HYDROLOGY K17/ D16 2 PLANS

AS BUILT DRAINAGE SCHEME
(PAGHANIAN RESTAURANT)
FOR
NICK KAY CONST. CO.

PROJECT
NEW RESTAURANT FOR
VRC & VRB PARTNERSHIP
1121 MONROE STREET N.E.
ALBUQUERQUE, N.MEX.

SHEET TITLE
SITE PLAN
FOUNDATION PLAN

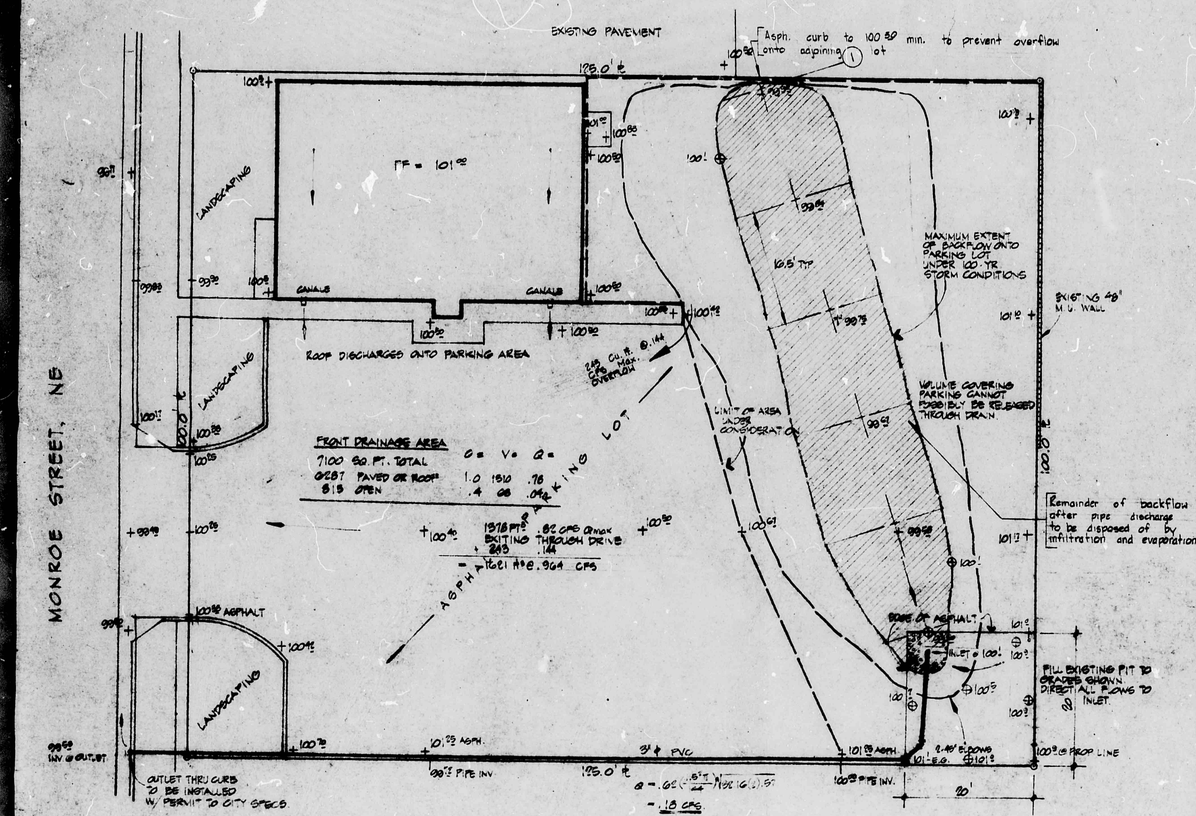
APPROVED FOR DRAINAGE
4-27-81
DATE
SIGNATURE P.E.
TITLE
ADVISE DRAINAGE INSPECTOR WHEN GRADING EXECUTED
Revised plan approved — No ponding was required per the original plan.

Revised 4-22-81

SITE PLAN

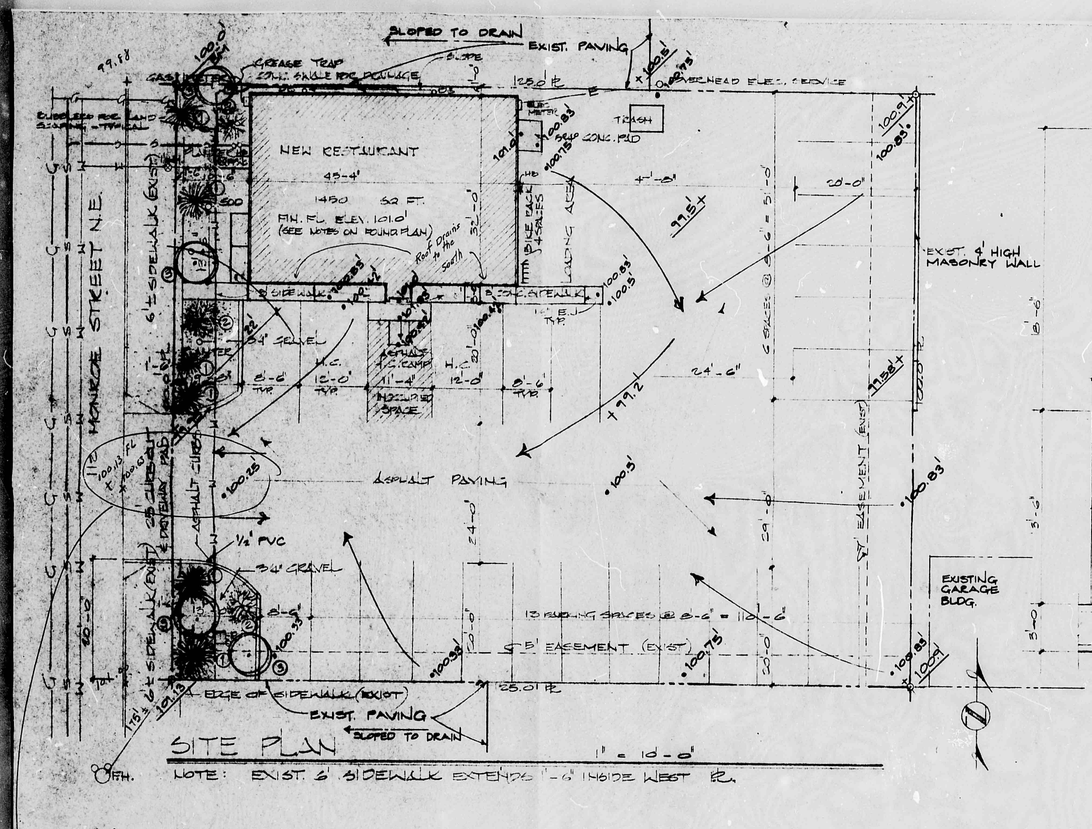
PRELIMINARY REVIEWED BY CALL 9-25-80. I FELT HIM THAT THE P.L. MUST BE 3' ABOVE TOP OF CURB. 9/26/

WILL SUBMIT REVISED COPY
